IFB No. 2025-35

Northern District Wastewater Treatment Plant (NDWWTP) Facility Damage Mawar Repairs Response for Inquiries No. 1

PERIMETER FENCE DETAILS

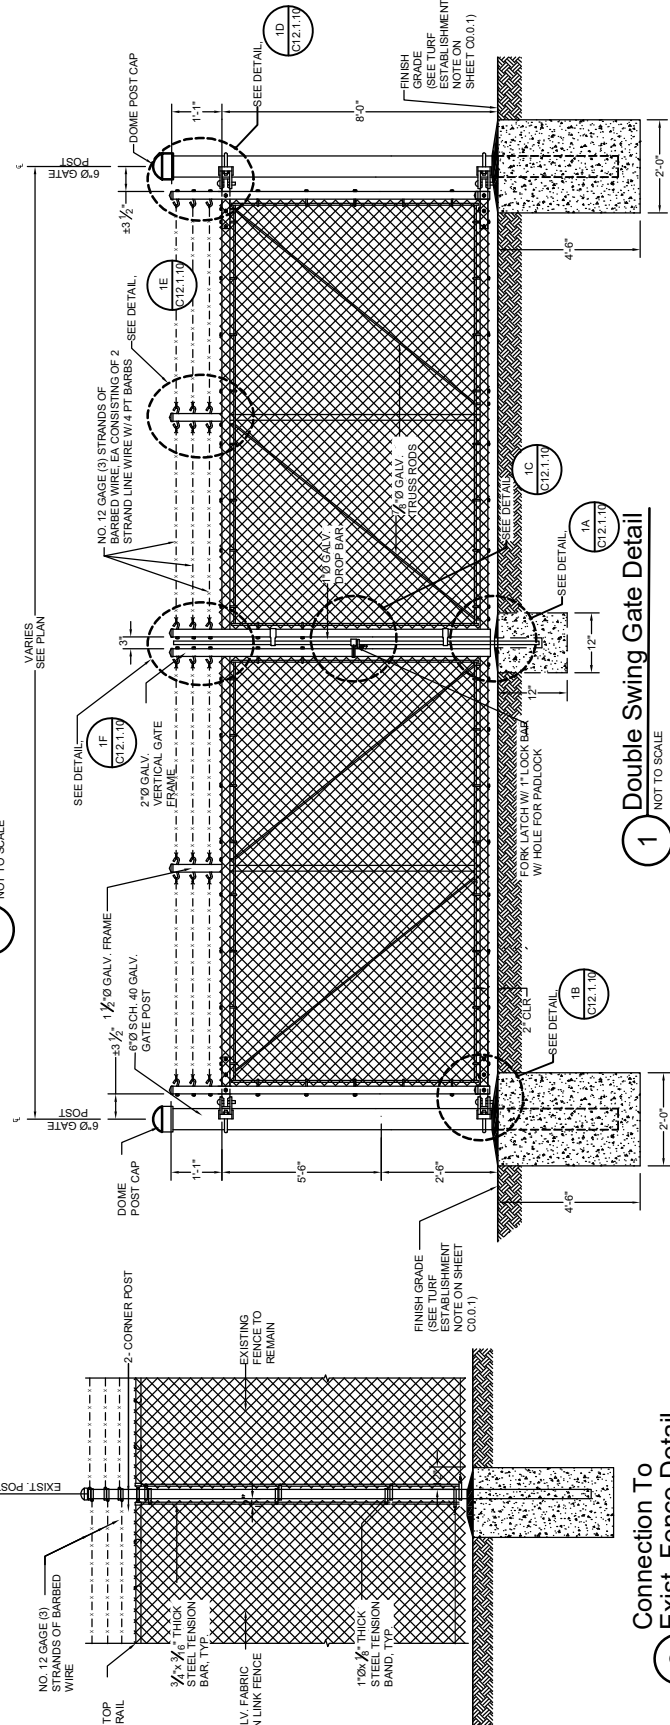
Area 2 - Reservoir Tank - Request detail drawing of the Reservoir Tank roof detail showing the dimension and specs of the cover including connection detail. Area 2 - Utility Hatch - The complete specifications and Detail Plan of the Utility Hatch Hydraulic Guides, Hatch connectors & Hatch Levers Area 2 - UV Area - Requesting complete specification of Channel Covers. Requesting as-built plans on those areas requiring the replacement of covers. 5.0 Facility Damage, Fencing Area 2 - Fencing- Requesting clarification if the Main Gate 2 will be replaced or repaired only. Section 5- Fencing- Clarification if the 10 each stands for aluminum wire ties or replacement of 10 line posts including aluminum Wire Ties.	See attached drawings. See attached drawings. See attached drawings Main Gate 2 shall be replaced, see attached drawings Provide 10 line posts, see attached drawings.
--	---
